Addendum No.: 1

Date Of Addendum: 09/07/18

Master Plan Phase III Renovations and Additions
Norwalk Community College
188 Richards Ave.
Norwalk, CT
BI – CTC – 467

7 DUCT LAGGING
MS.04 NOT TO SCALE

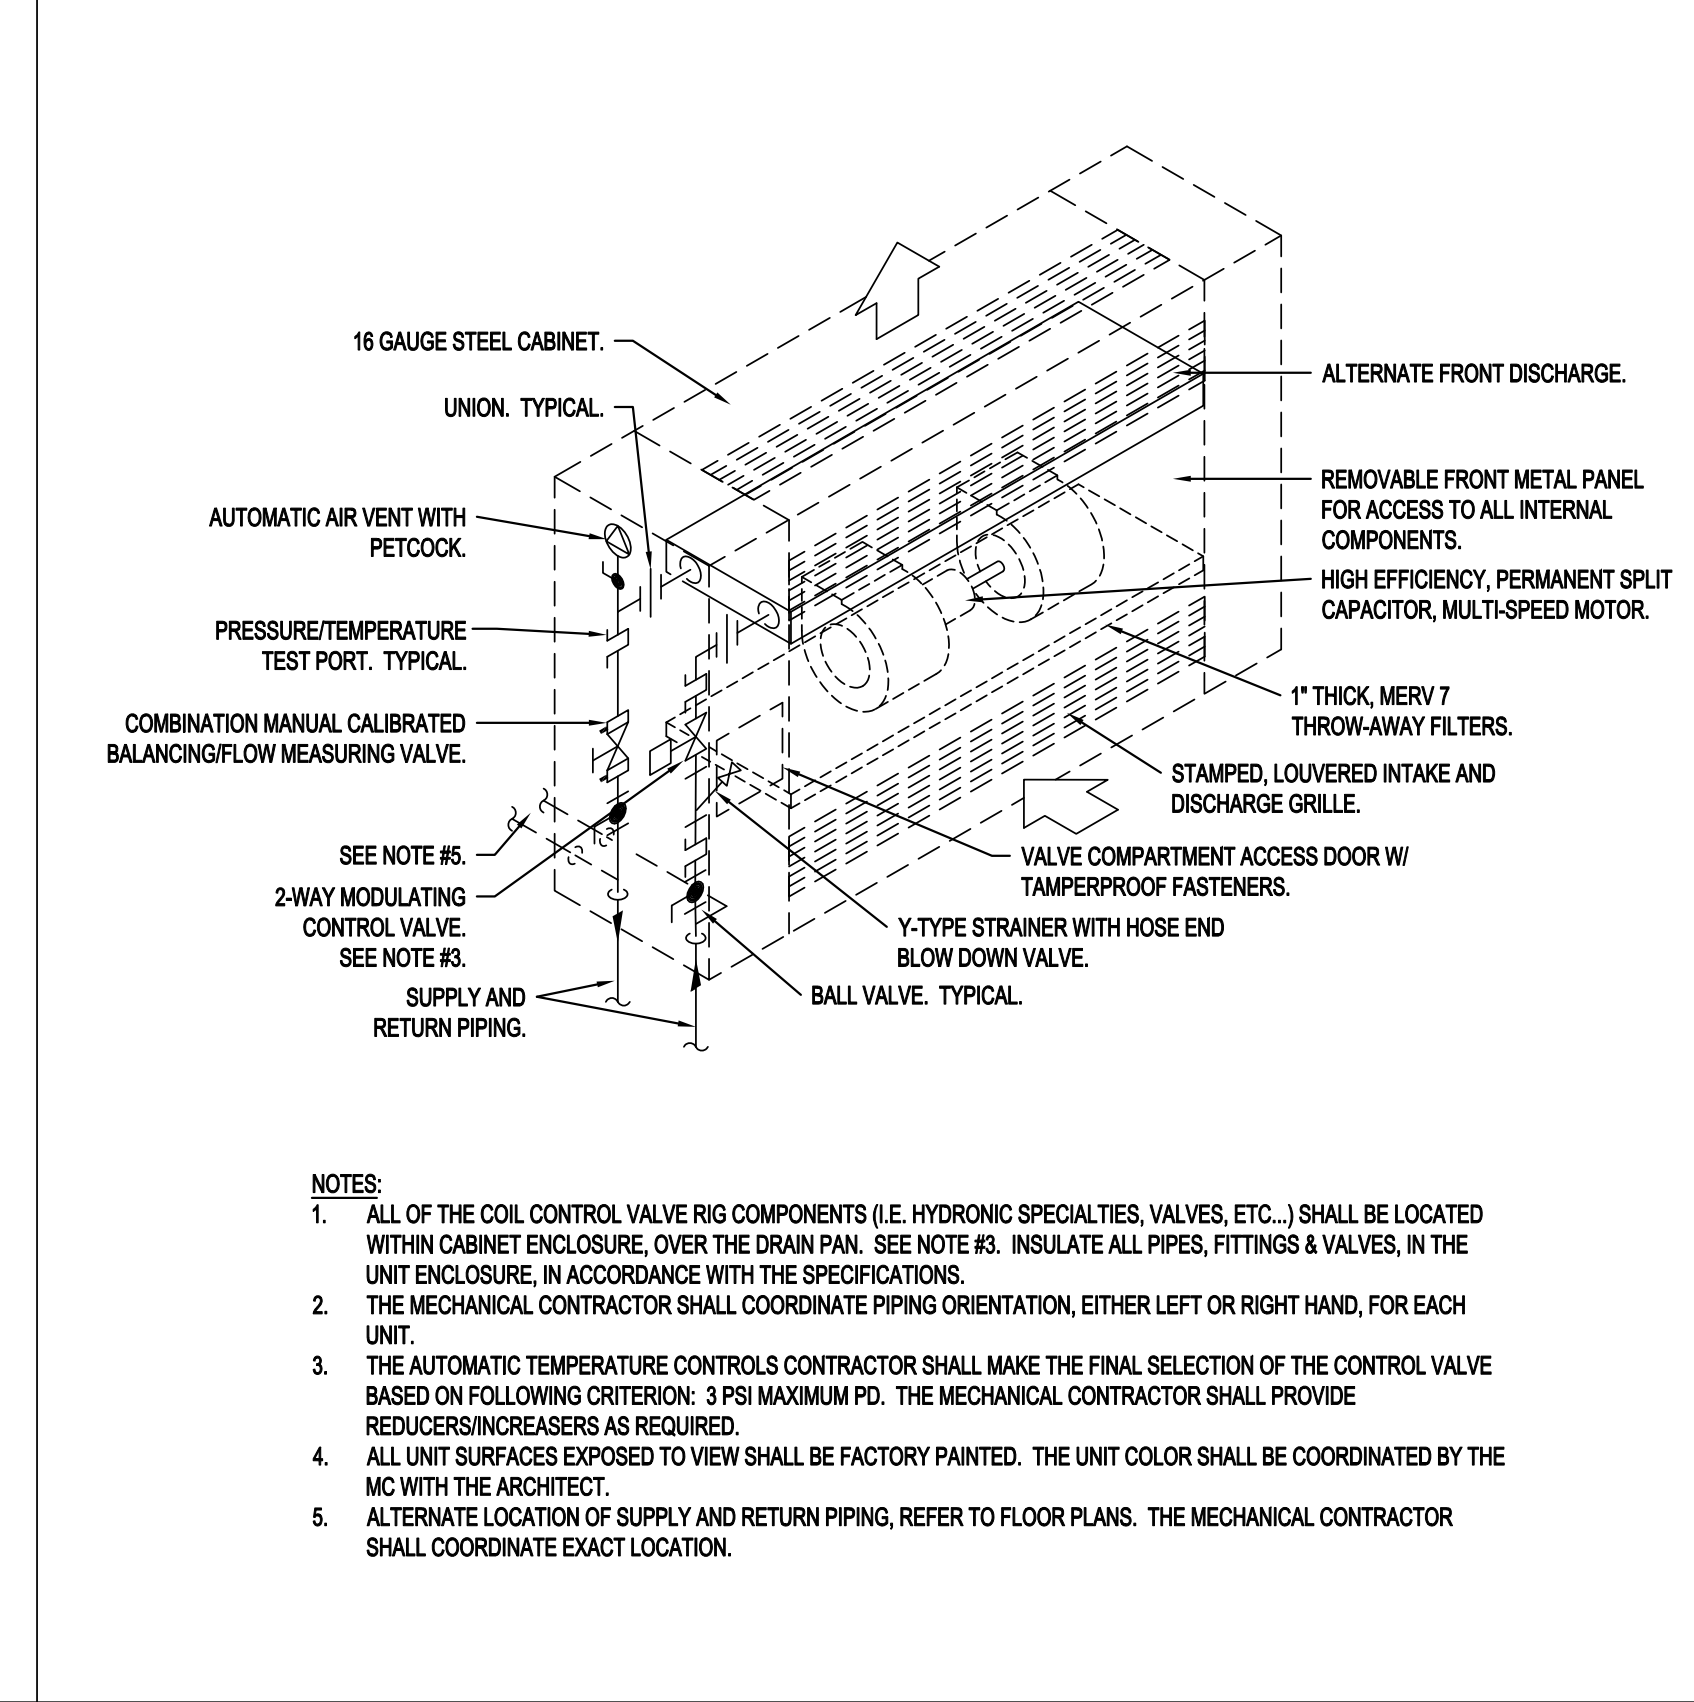
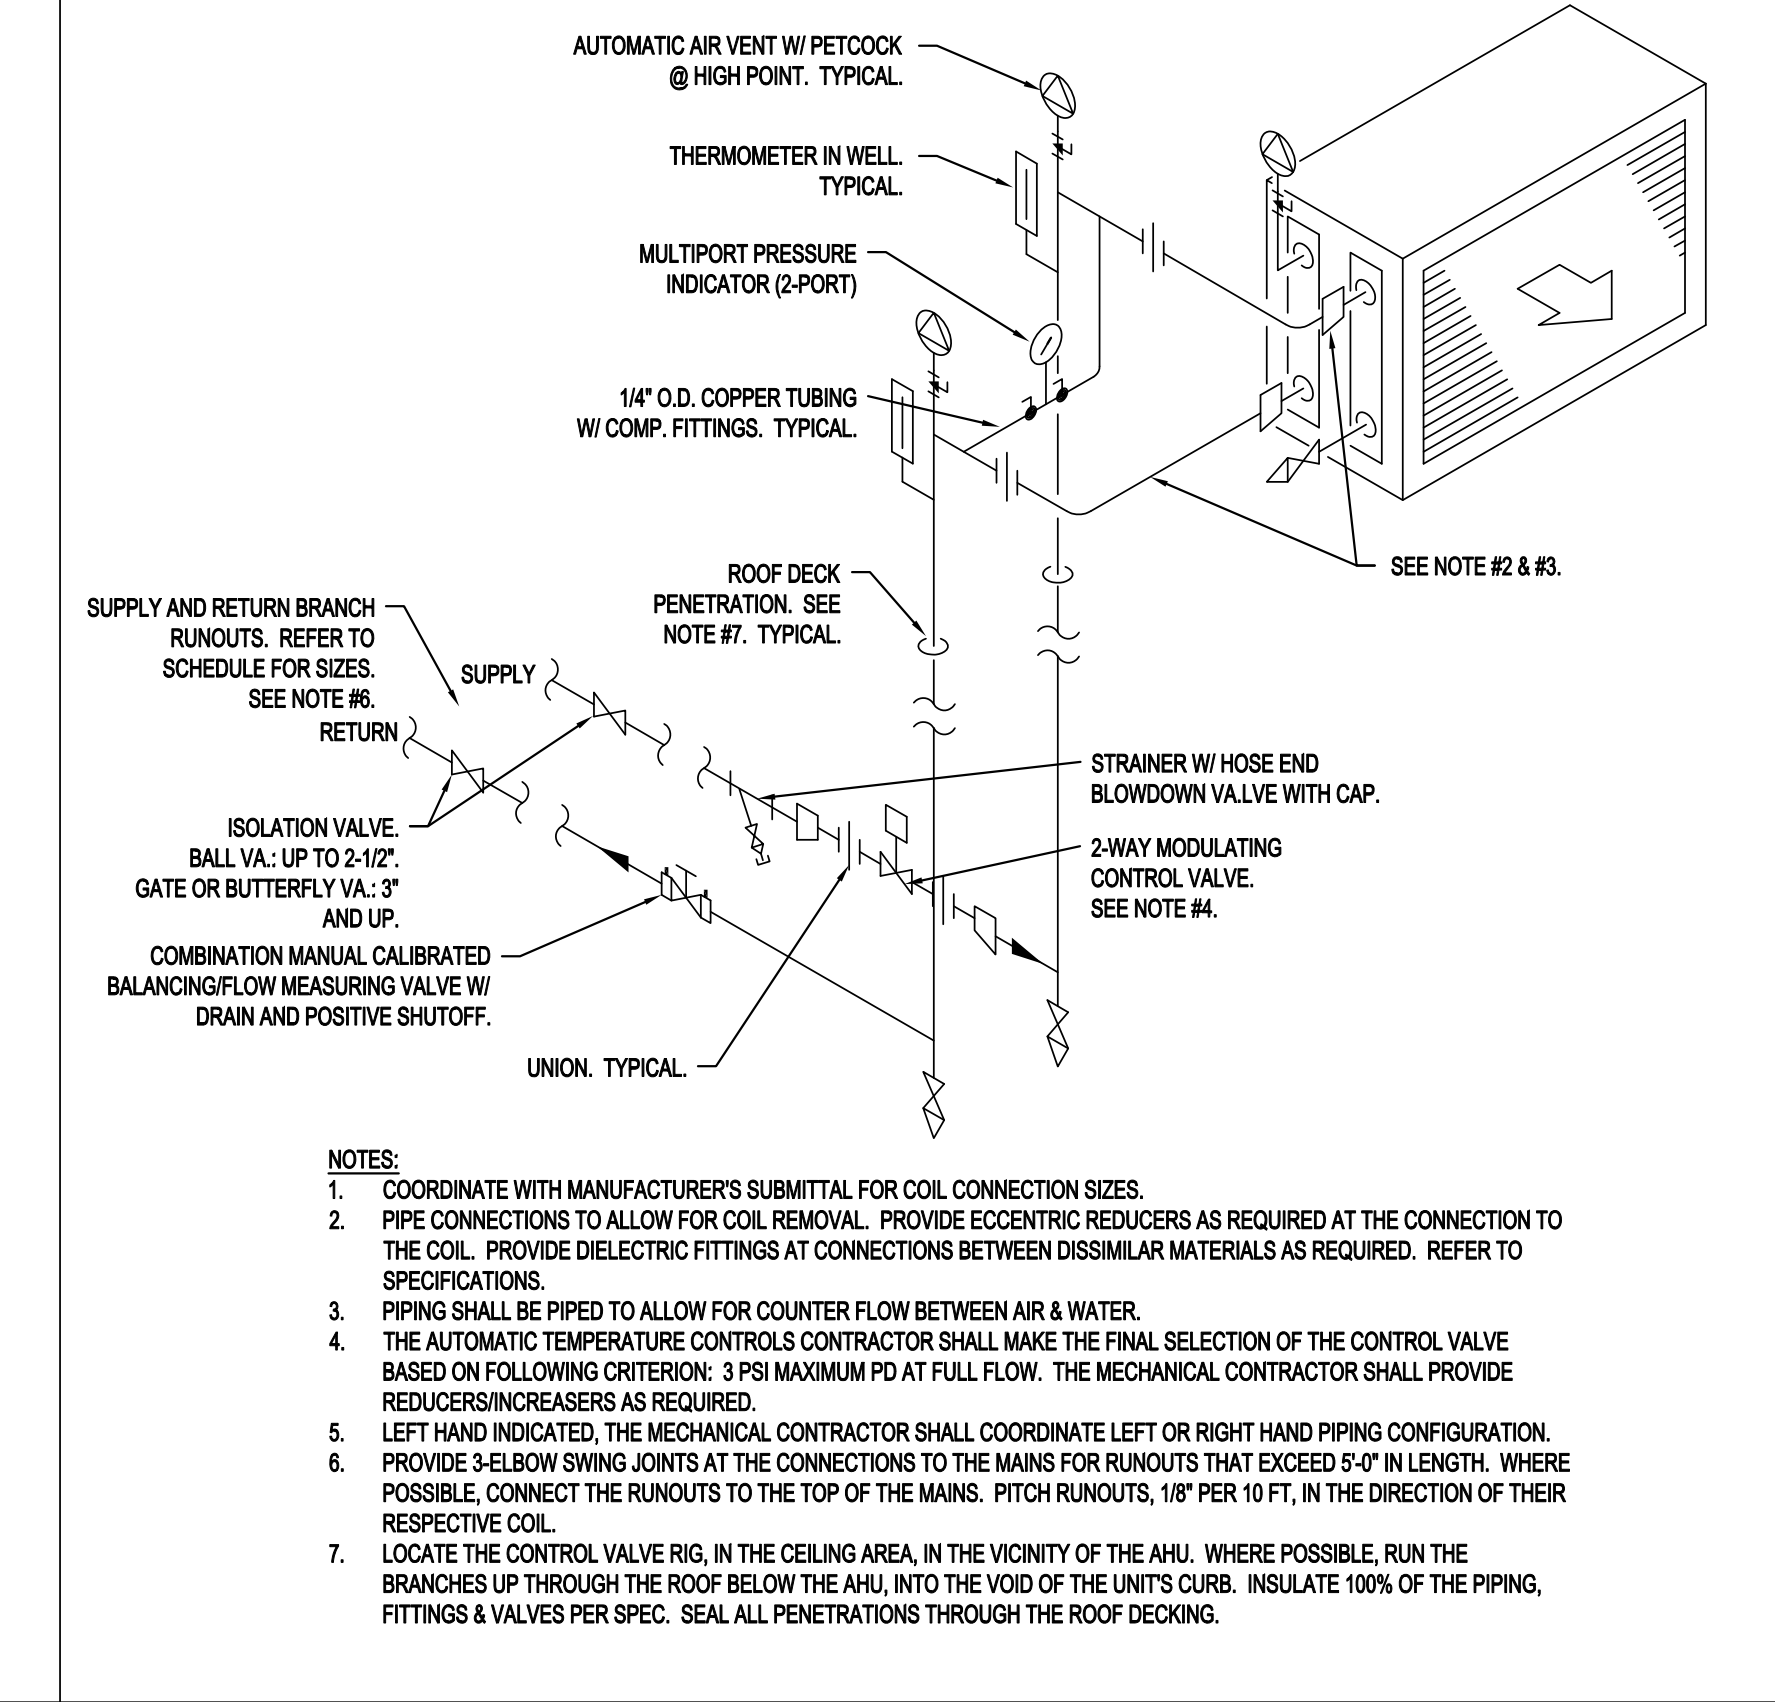
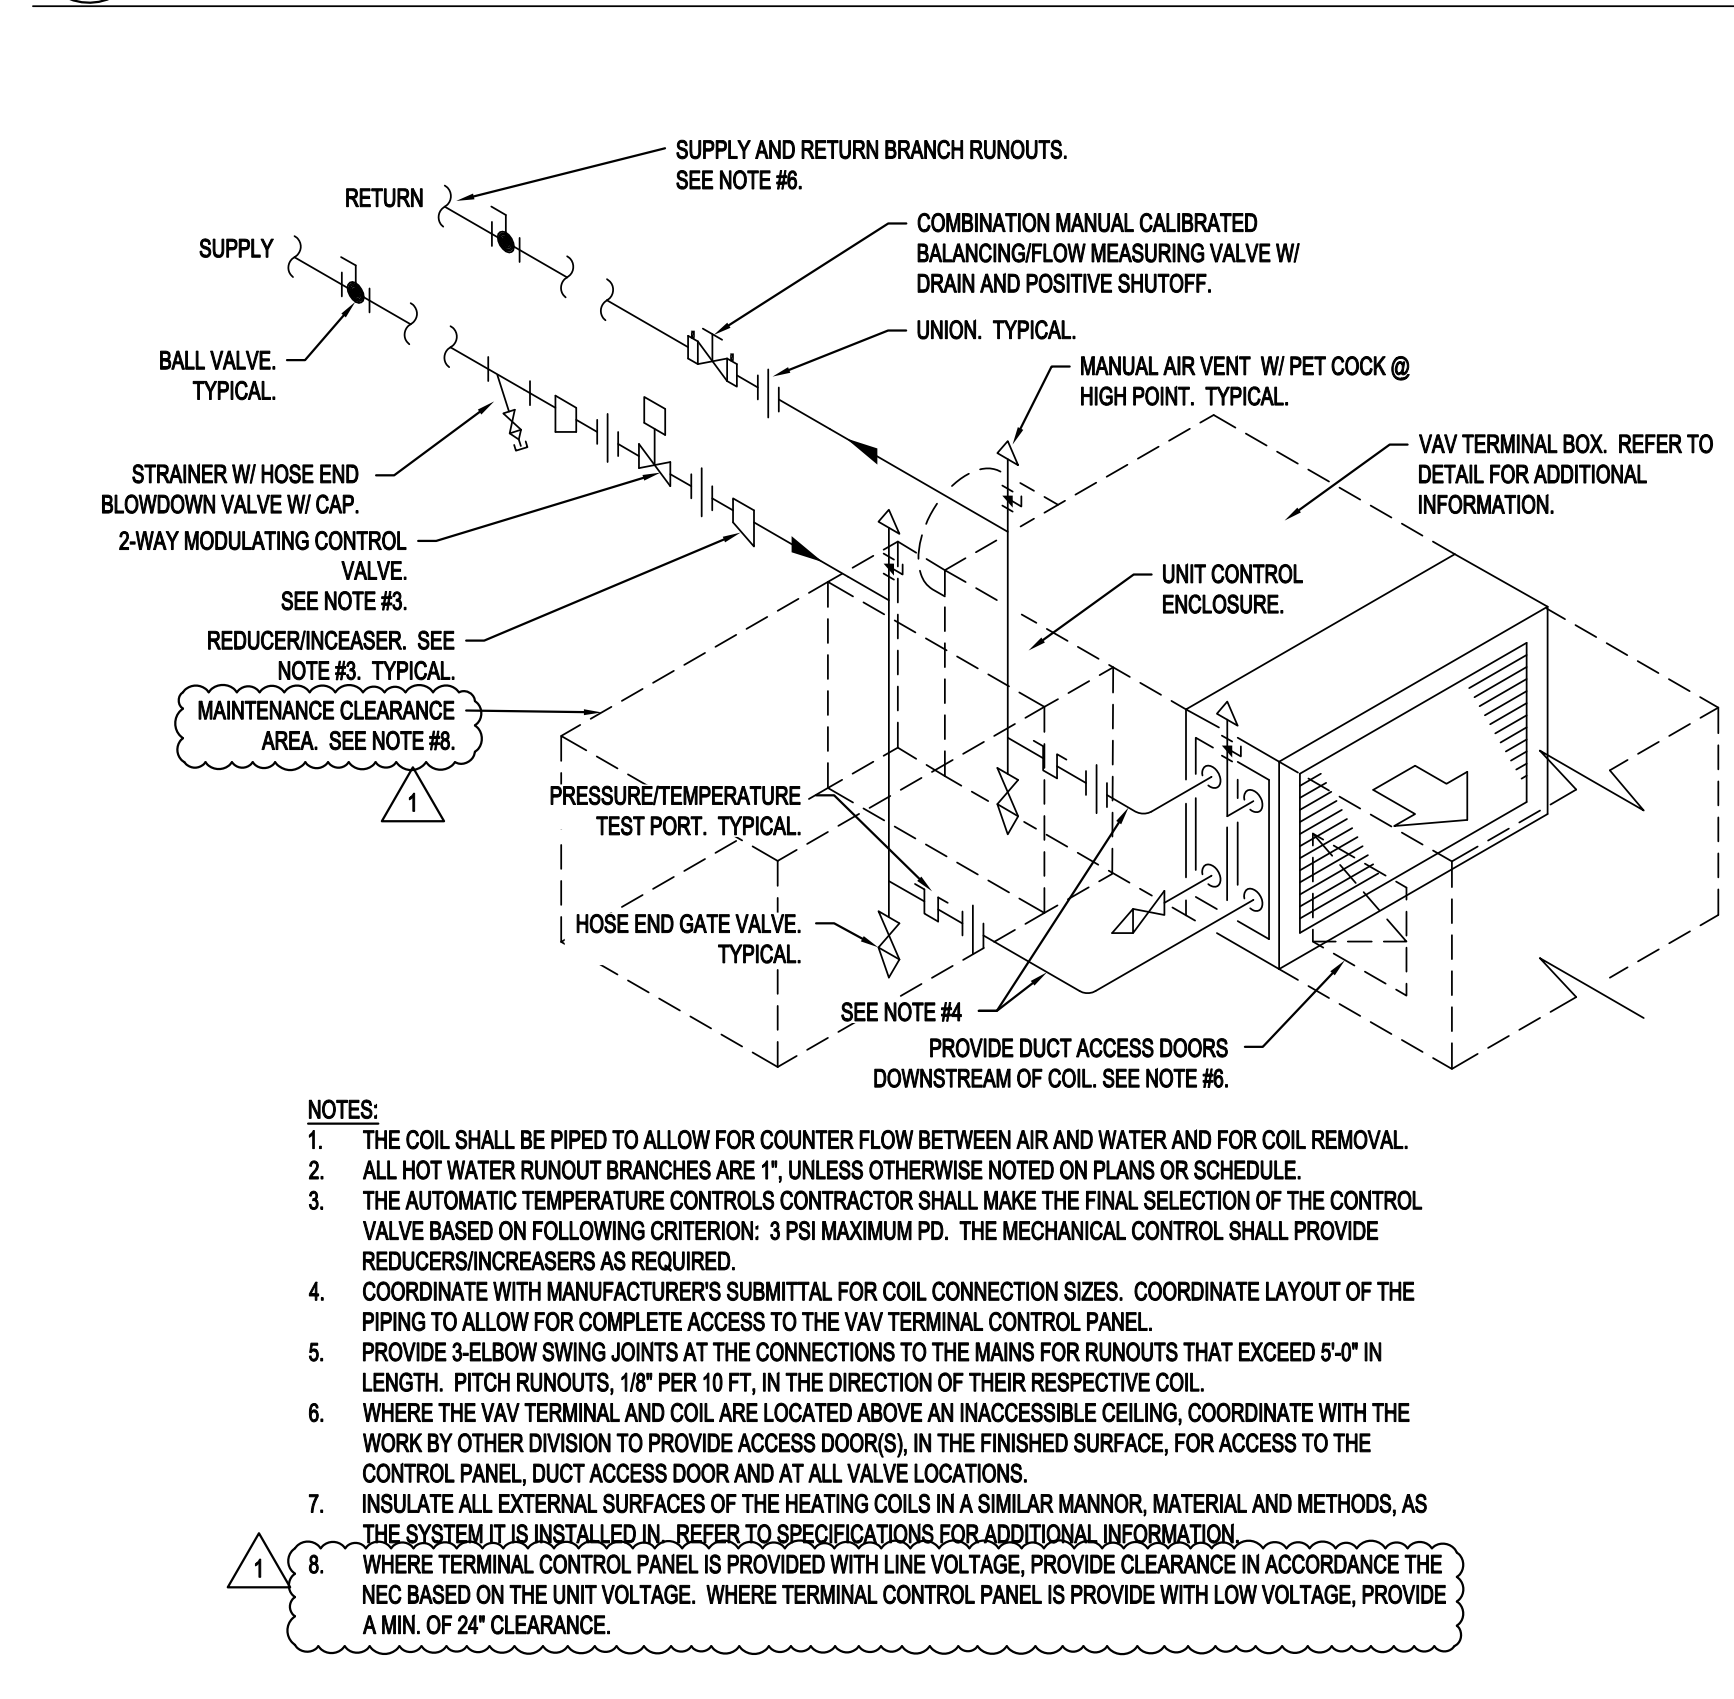
M5.04 – re-issued, Addendum No. 1, 09/07/18: Revised detail 11 to clarify VAV clearance requirements. Revised detail 7 to clarify duct lagging framing.
